### STAFF RECOMMENDATION 3653 Richland Avenue Lot 2, Richland Hall Development December 16, 2015

**Application:** New construction—infill and outbuilding; Setback determination  
**District:** Richland-West End Neighborhood Conservation Zoning Overlay  
**Council District:** 24  
**Map and Parcel Number:** 10409028100  
**Applicant:** Chad Gore, Mike Ford Builders  
**Project Lead:** Melissa Baldock, melissa.baldock@nashville.gov

**Description of Project:** Application is to construct a new single family infill and an outbuilding. Both the infill and the outbuilding are to be located three feet (3') from the interior property line. Since base zoning requires a five foot (5') side setback for both structures, the project requires a setback determination

**SITE PLAN**

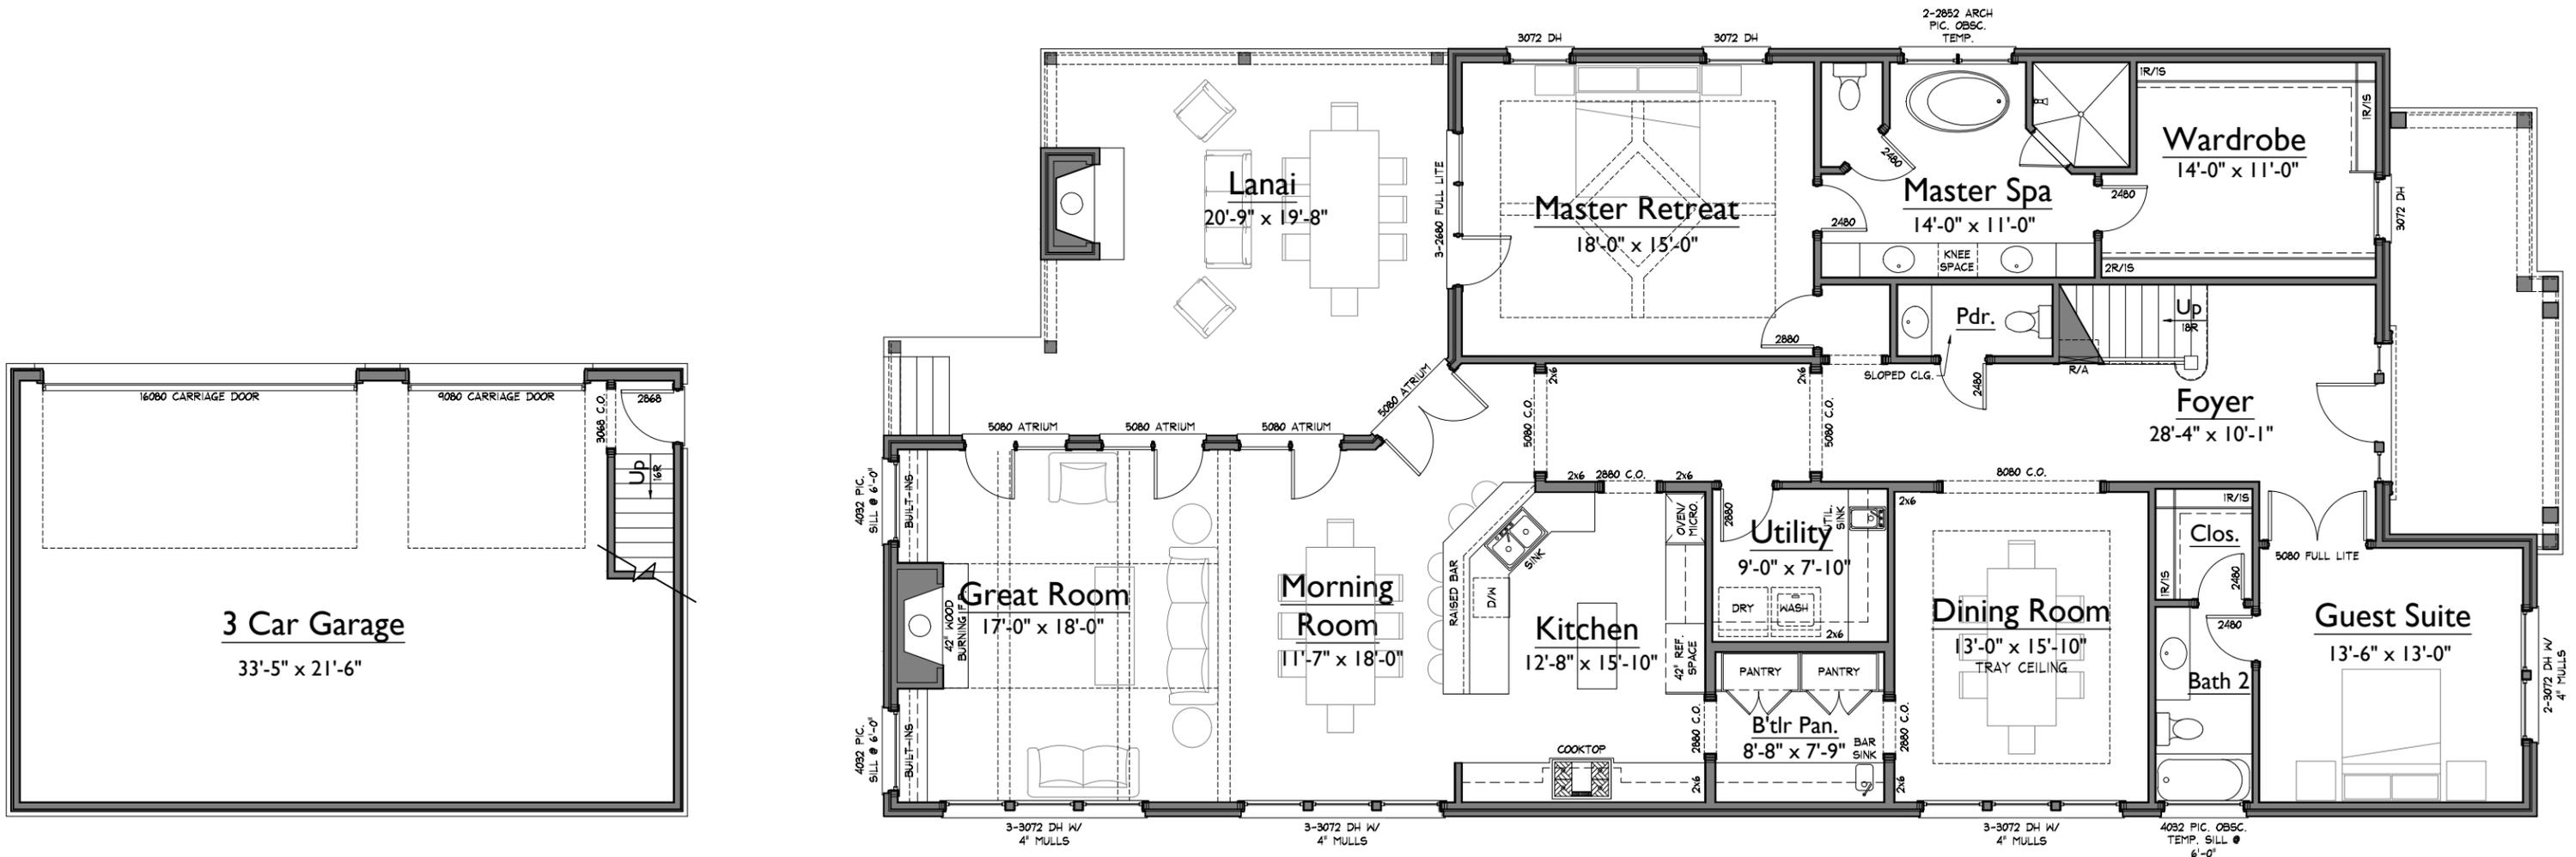
Setback & Rhythm of Spacing: In May, the Commission approved a plan that showed that the front-yard setbacks for new construction on the south side of Richland Avenue will be approximately forty-feet (40'), matching the context of the one historic building on that block, Davidson Hall. The site plan for 3653 Richland Avenue shows a front setback of forty feet (40').

The right side elevation will be seven feet (7') from the side property line, which meets the base zoning setback of five feet (5'). On the left side, base zoning requires a five foot (5') side setback, but the applicant is proposing to set the infill just three feet (3') from the side property line. Staff finds this reduced side setback to be appropriate because there are other homes in the immediate vicinity that do not meet the required five foot (5') side setback. In addition, the infill is part of a larger development, and the reduced setback will affect the parcel next door at 3649 Richland Avenue, which is also part of the larger development. Staff has yet to review the site plan for 3649, but has directed the applicant that the right side of 3649 needs to be set more than seven feet (7') from the side property line. This will ensure there is at least ten feet (10') in between nos. 3653 and 3649 Richland Avenue and that the reduced side setback will not affect overall rhythm of spacing on the street.

Appurtenances & Utilities: The drawings indicate that the applicant intends to maintain the existing stone wall along Richland Avenue. The location of the HVAC and other utilities was not noted on the site plan. Staff asks that the HVAC be located on the rear façade, or on either side facade, beyond the midpoint of the house. With the staff's approval of the location of the HVAC unit, Staff finds that the infill meets Section II.B.1. i. of the design guidelines.

Base zoning requires that outbuildings larger than seven hundred square feet (700 sq. ft.) be located twenty feet (20') from the rear property line and five feet (5') from the side property lines. The outbuilding will be approximately thirty feet (30') from the rear property line, although it will appear to be much closer because it is five feet (5') from the new alley created on the rear of the property. The outbuilding will meet the right side setback, but will require a side setback determination left side property line. It will be just three feet (3') from the left side property line rather than the required five feet (5'). Staff finds the proposed three foot (3') side setback to be appropriate because it will line up with the setback of the proposed infill. In addition, historically, outbuildings were located close to or on the side property lines. There will be approximately ten feet (10') in between the infill and the outbuilding.

1. The foundation be no taller than two feet (2');
2. The finished floor height be consistent with the finished floor heights of neighboring historic houses, to be verified by MHZC staff in the field;
3. The foundation material be stone or stucco, or if the foundation is to be brick, it be a different color than the brick on the walls above in order to visually differentiate between the foundation and the wall;
4. Staff approve all windows and doors, roof shingle color, and brick and stone samples prior to purchase and installation of these materials; and
5. The HVAC shall be located behind the house or on either side, beyond the mid-point of the house.

**ELEVATIONS**

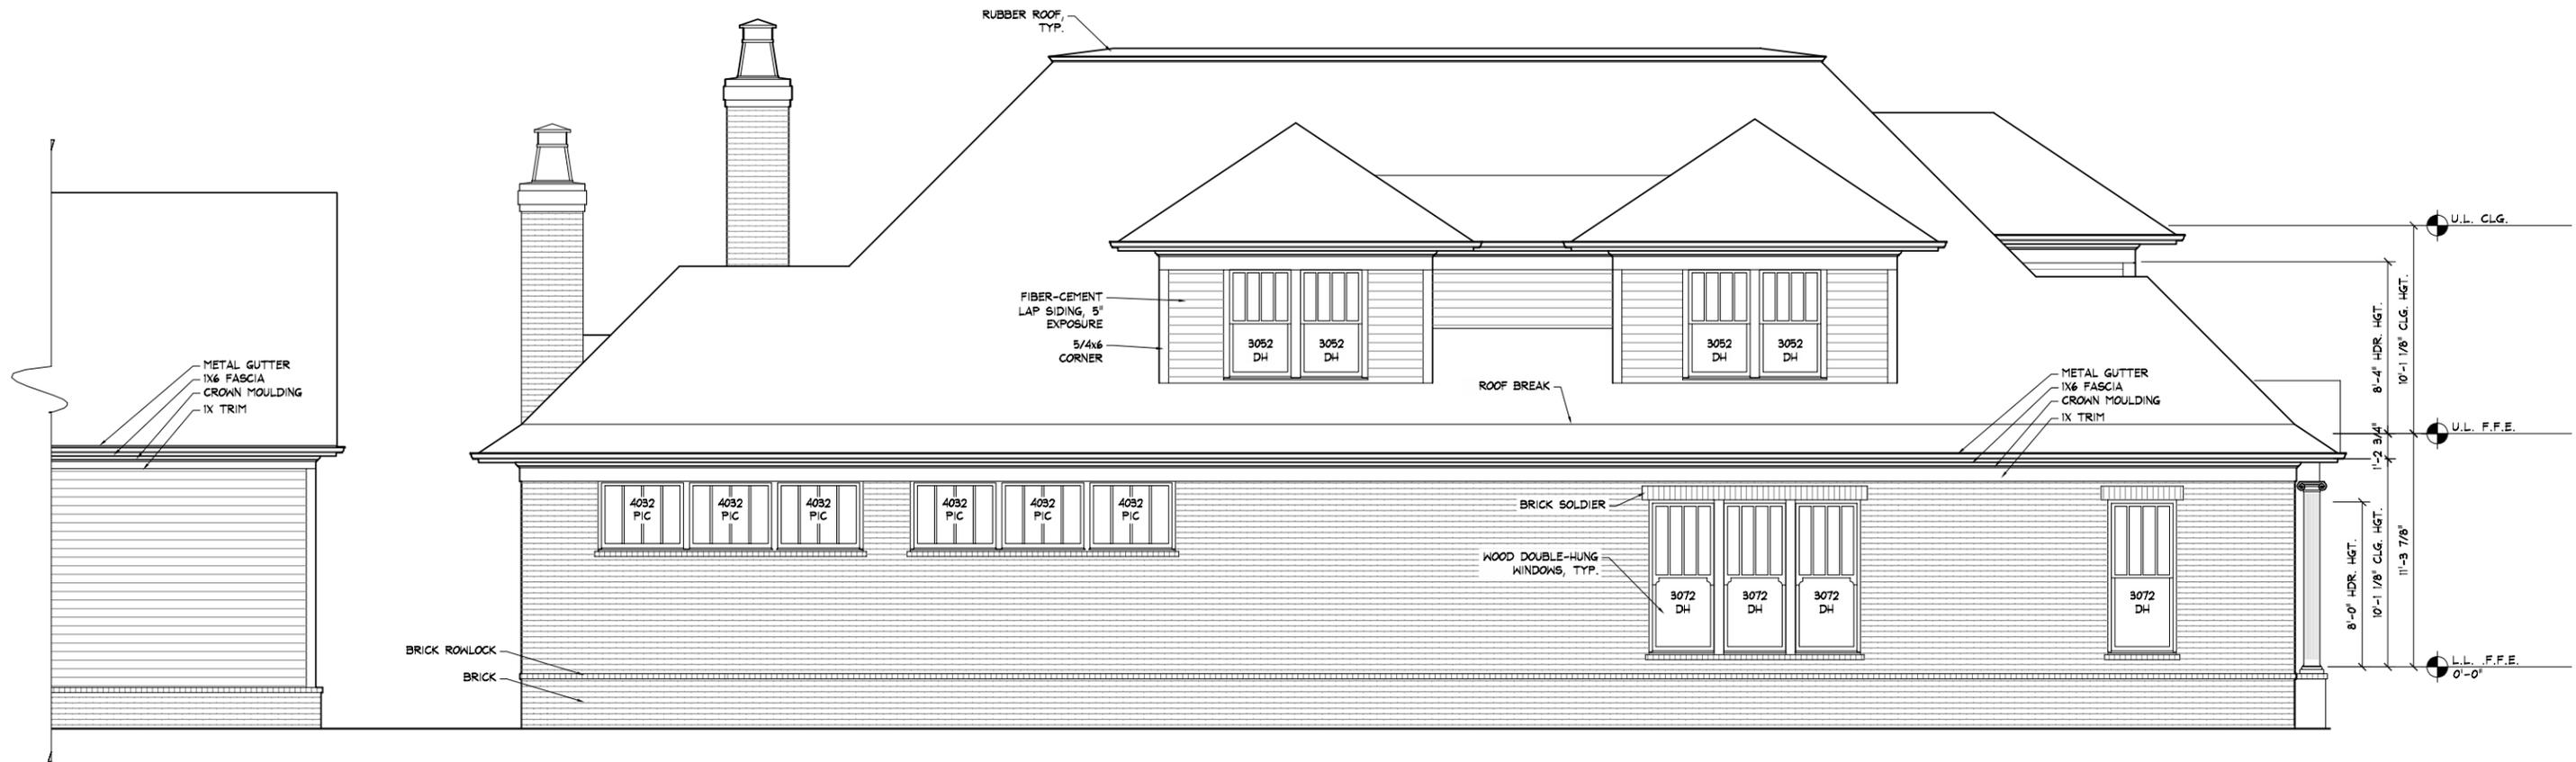
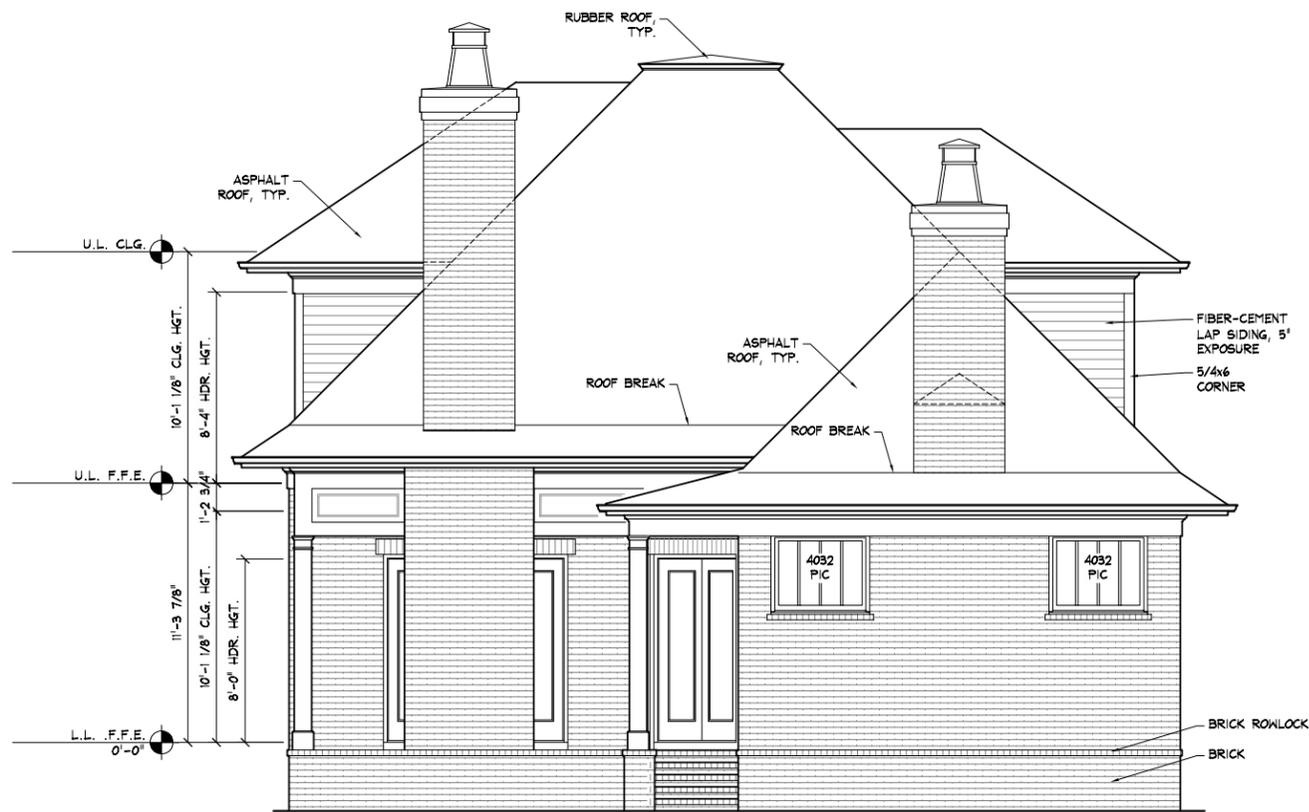
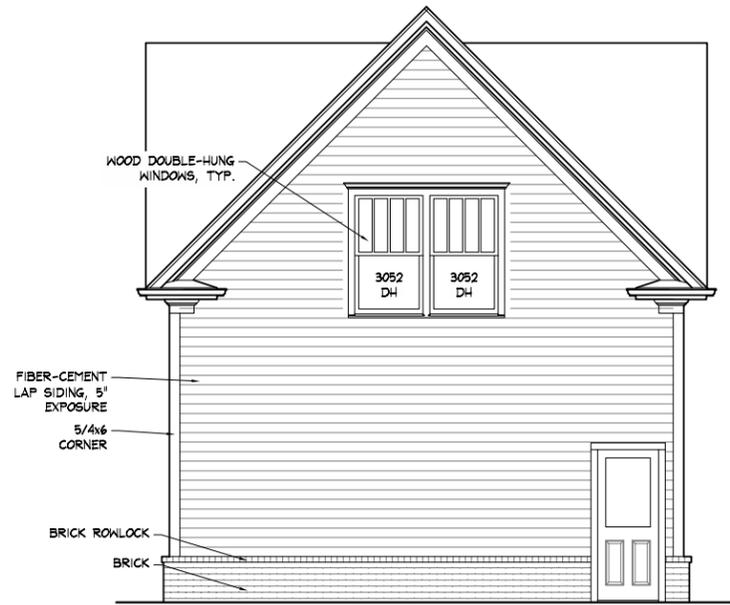
**Height & Scale:** The proposed infill will be one-and-a-half stories with an eave height of fourteen feet, six inches from grade and a ridge height of approximately thirty-two feet (32') from grade. Staff finds that this meets the overall historic context, as there are both

one and a half and two-story houses in the immediate vicinity, and these houses have heights ranging from thirty to forty-four feet (30' – 40') in height. The foundation height is drawn as approximately two feet, six inches (2'6"). The lot is fairly flat, and staff recommends that the foundation be no taller than two feet (2') at its highest point.

Materials: The primary cladding material will be brick, and staff recommends approval of a brick sample prior to purchase and installation. The primary foundation is also to be brick, with a header brick course separating the foundation from the wall above. Historically, there was a change in material from the foundation to the wall above, and staff therefore recommends that the foundation be another masonry material than brick, like stone or stucco. Alternatively, if the foundation is to be brick, then the color of the brick for the foundation should be different than the color of the brick for the wall above.

Smooth fiber cement panels will be used on the front dormer. Smooth-face fiber cement lap siding with a five inch (5") reveal will be used on the other dormers and on the side of the front dormer. The trim and the columns will be cement fiberboard. The main roof will be asphalt shingle, and staff recommends approval of the shingle color and texture.

Roof form: The primary roof form is a hipped roof with an 11/12 pitch. There are three hipped dormers with 7/12 pitches. The front dormer is set off the ridge by three feet (3'). It stacks on the wall below, but staff finds this to be appropriate because the wall below is inset eight feet (8') from the front of the house and because the dormer is otherwise proportional to the overall infill design. The dormer on the left is also set off the ridge by several feet and is set back from the wall below by two feet (2'). The dormer on the right façade is set off the ridge by one foot (1'), but stacks on the wall below. Staff finds that the dormer stacking on the wall below is acceptable in this instance because it is located approximately thirty-eight feet (38') from the front of the house, and its visibility will be minimal.

The central portion of the porch roof will be pedimented with a 5/12 slope. The right side portion of the porch will be hipped with a 3/12 slope. Staff finds that the proposed roof forms are typical for historic one-and-a-half story houses in the overlay, and finds that the roof forms meet Section II.B.1.e. of the design guidelines.

Proportion and Rhythm of Openings: The primary windows on the infill are twice as tall as they are wide, thereby meeting the historic proportions of openings. There are no large expanses of wall space without a window or door opening on the right facade. On the left elevation, there is an expanse of twenty-three feet (23') without a window or a door opening. Staff finds this expanse to be appropriate because it is on the interior of the lot, and is located over thirty feet (30') behind the front wall of the house, minimizing its visibility. Staff finds that the infill's proportion and rhythm of openings meet Section II.B.1.g. of the design guidelines.
